The CAISO received comments on the topics discussed at the September 23-24, 2024 stakeholder call from the following:

The following are the CAISO's responses to the comments

Stakeholder Comments
2024-2025 Transmission Planning Process Stakeholder Meeting
September 23-24, 2024

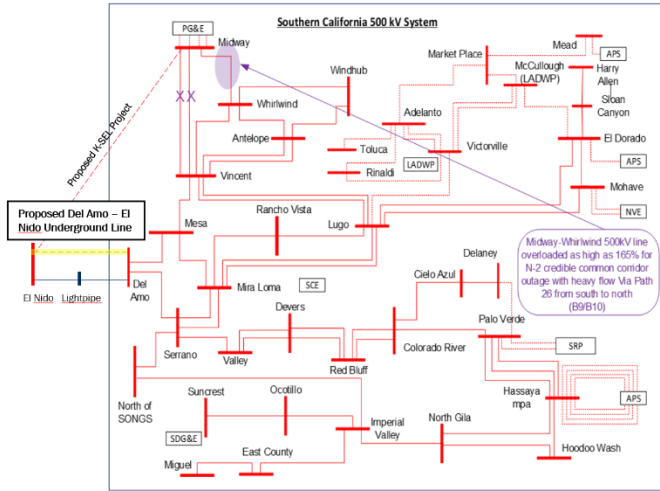
No	Submitting Organization	Comment Submitted	CAISO Response																																								
		<p>SVP performed its own studies, using the 2028 and 2034 short circuit cases from the 2023-2024 TPP as the starting (pre-project) cases. SVP then added the above-mentioned Hybrid project to develop the post-project cases for the years 2028 and 2034. In the 2028 post-project cases, SVP assumed all the elements of the Hybrid project would be built, except for the San Jose B to NRS 230kV line. [5] Table 1 summarizes the breaker fault duty issues under both pre- and post-project cases in 2028 and 2034 on the NRS 230kV bus. It shows that with the original (previously-approved) CAISO plan (pre-project case), none of the 230kV breakers at NRS are overdutied. With the addition of the 230kV lines between Newark and NRS and San Jose B to NRS, the overduty issues increase significantly (well exceeding the threshold of 90%) on the existing NRS 230kV breakers. These results demonstrate that the four existing 40kA breakers at NRS are insufficient with the Hybrid project and will need to be replaced.</p> <p>Table 1: Pre-and Post-Hybrid Project Fault Duty (%) on NRS 230kV Bus</p>

<p>N/A: Not Applicable</p> <p>SVP's studies indicate a similar breaker fault overduty occurs with respect to the NRS 115kV bus. Table 2 summarizes the breaker fault duty issues under both pre- and post-project cases in 2028 and 2034 on the NRS 115kV bus. It shows that with the original (previously-approved) CAISO plan, none of the 115kV breakers at NRS are overdutied. With the addition of the Hybrid project,</p>	Breaker	Breaker Rating	2028		2034		Pre-Project	Post-Project	Pre-Project	Post-Project	NRS-SSS 230kV	40kA	58%	81%	60%	94.9%	NRS 230/115kV transformer	40kA	75%	99%	77%	111%	NRS 230kV to HVDC	63kA	47%	N/A	48%	N/A	NRS 230kV to Newark	63kA	N/A	47%	N/A	55%	NRS 230kV to San Jose B	63kA	N/A	N/A	N/A	64%	the hybrid transmission project for the San Jose area and will continue to develop complementary projects to tackle the long-term reliability issues identified.
Breaker	Breaker Rating	2028			2034																																						
		Pre-Project	Post-Project	Pre-Project	Post-Project																																						
NRS-SSS 230kV	40kA	58%	81%	60%	94.9%																																						
NRS 230/115kV transformer	40kA	75%	99%	77%	111%																																						
NRS 230kV to HVDC	63kA	47%	N/A	48%	N/A																																						
NRS 230kV to Newark	63kA	N/A	47%	N/A	55%																																						
NRS 230kV to San Jose B	63kA	N/A	N/A	N/A	64%

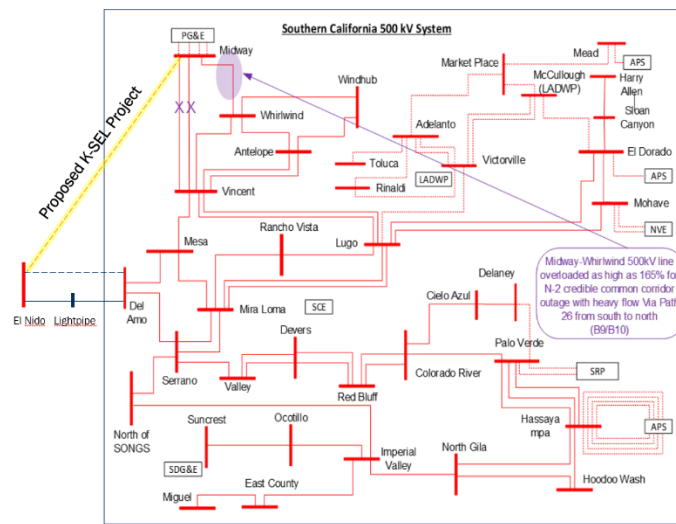
<p>As shown in Table 3, there were no P1 overloads found on one of the SVP's import facilities, i.e., FMC-KRS (Kifer) 115kV found in the pre-Project case. However, with the Hybrid project, under the loss of the new San Jose B to NRS 230kV, significant overloads are identified as early as in 2029. The reconductoring of PG&E's 115 kV lines is necessary to maximize the impact of the proposed 230 kV project. Therefore, SVP supports the PG&E Request Window (RW) project alternative that includes the reconductoring of the FMC-KRS 115kV line.^[6]</p> <p>SVP also observed considerably lower voltages with the Hybrid Project under both normal and contingency conditions. In particular, voltages at Newark are 0.98 PU (1.0 PU), and NRS 230 kV are 0.973 PU (0.992 PU) under N-0 in post-Project (pre-Project) cases. Such low voltages under the post-project case</p>	Overloaded Facility	Contingency	2029		2034		2039		Pre-Project	Post-Project	Pre-Project	Post-Project	Pre-Project	Post-Project	FMC-KRS 115kV	New San Jose B to NRS 230kV (P1)	N/A	155.0%	N/A	151.0%	N/A	142.0%	
Overloaded Facility	Contingency	2029			2034		2039																		
		Pre-Project	Post-Project	Pre-Project	Post-Project	Pre-Project	Post-Project																		
FMC-KRS 115kV	New San Jose B to NRS 230kV (P1)	N/A	155.0%	N/A	151.0%	N/A	142.0%

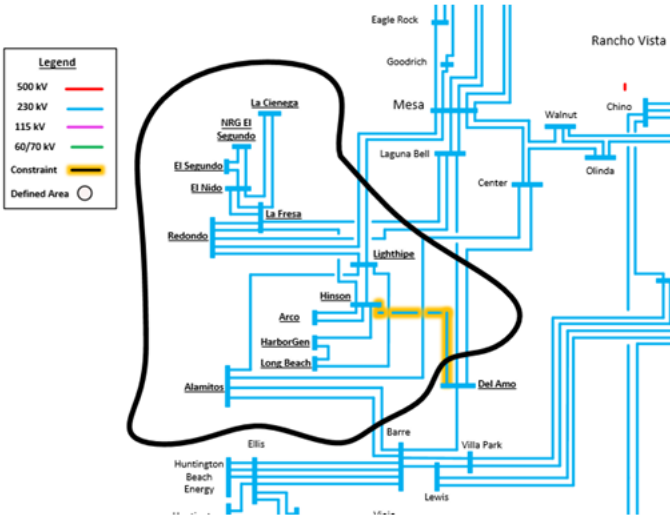
No	Submitting Organization	Comment Submitted			CAISO Response
		FMC – San Jose B 115 kV	110.4%	121.4%	
		These overloads indicate that certain PG&E 115kV facilities, such as PG&E's Los Esteros–Nortech 115 kV line, PG&E's Nortech-NRS 300 115 kV line, and PG&E's Newark-NRS 115kV, should be reconducted if the NRS-San Jose B 230kV AC segment of the Hybrid project cannot be constructed and energized by the expected in-service date.			
1M	Southern California Edison	No comment			
1N	Terra-Gen, LLC	No comment			
10	California Public Utilities Commission	<p>Staff of the California Public Utilities Commission in the Energy Division (CPUC Staff or Staff) develop and administer energy policy and programs to serve the public interest, advise the CPUC, and ensure compliance with CPUC decisions and statutory mandates. The CPUC Energy Division Staff provide objective and expert analyses that promote reliable, safe, and environmentally sound energy services at just and reasonable rates for the people of California.[1] Further, CPUC Staff advocate on behalf of California ratepayers at the Federal Energy Regulatory Commission (FERC), under whose jurisdiction the 2024-2025 Transmission Plan would fall.</p> <p>CPUC Staff appreciate this opportunity to provide these comments.</p> <p>CPUC Staff have no comments at this time on the preliminary reliability results for the North area.</p>
